MODEL
2019-2021MY Forte
(BDm)

NUMBER
052

TECHNICAL SERVICE BULLETIN

SUBJECT: FUEL TANK INLET CHECK VALVE (ICV) MODIFICATION

Fuel Inlet Check Valve

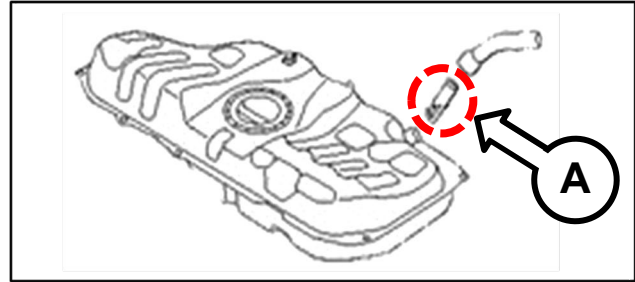
This bulletin provides information on the modification of the fuel tank Inlet Check Valve (ICV) on some 2019-2021MY Forte (BDm) vehicles produced from July 9, 2018 through December 2, 2020, which may exhibit fuel spit-back from the Fuel Filler Neck, after the tank has been filled up, and the nozzle clicks off. This condition may occur when the ICV in the fuel tank (at end of Fuel Filler Neck) becomes temporarily stuck in the open position due to the ICV ribs preventing the ICV from closing completely. Follow the procedure outlined in this publication to modify clearance between the ICV ribs and the flap to correct this condition.

ICV Flap Properly Closed

ICV Flap Stuck Open

ICV Post Procedure

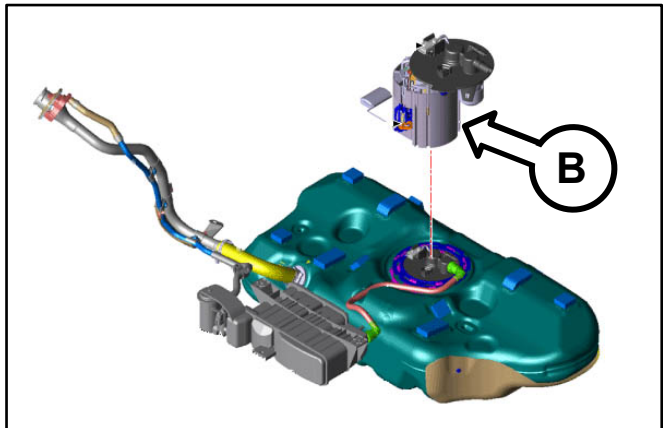
Because the Inlet Check Valve (ICV) (A) is located at the bottom of the fuel filler neck connection, inside the fuel tank, it cannot be accessed from outside. Follow the steps below to access the ICV through the fuel pump location.

2. Depressurize the fuel line by referring to the “Engine Control/Fuel System → Fuel Delivery System → Release Residual Pressure in Fuel Line” chapter in the applicable Shop Manual on KGIS.
3. Remove the fuel pump (B) by referring to the “Engine Control/Fuel System → Fuel Delivery System → Fuel Pump → Repair procedures” chapter in the applicable Shop Manual on KGIS.
4. Use a snake scope (C) (JSP97305 or equivalent) to locate the ICV (A).

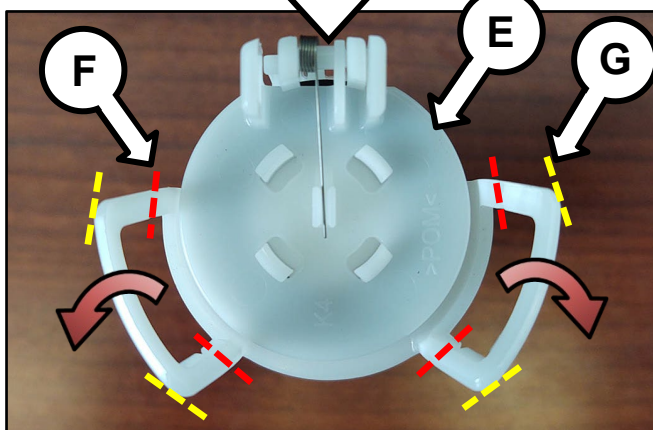
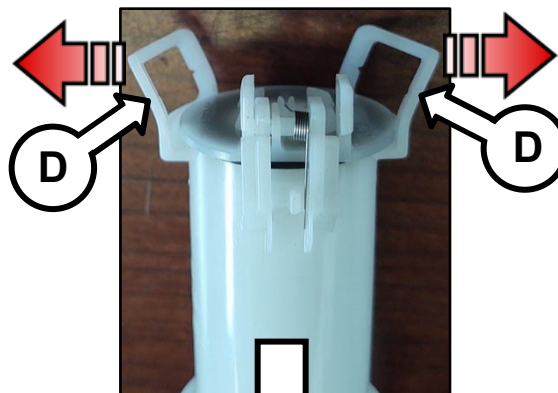
6. Using your hand (with ICV in the fuel tank), bend each rib (D) outward, away from the flap (E), to a 90° angle, or more, and allow to relax as shown.

- F: Original position (Red line)
- G: New modified position (Yellow line)

ICV is shown outside of vehicle for illustration purposes only.

[Video: Bending ICV Ribs](#)

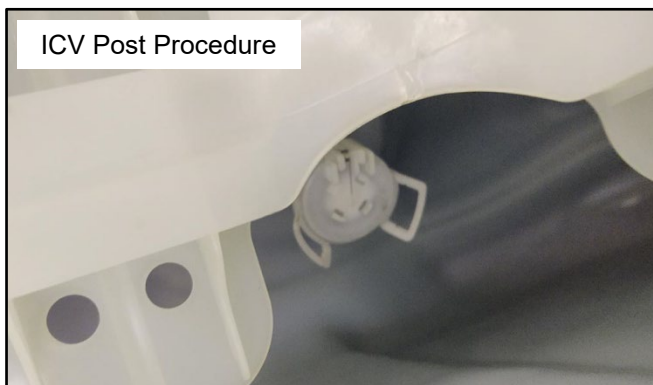
Refer to attached video below for an example.

Note: In video, cut-away fuel tank is shown for demonstration purpose only.
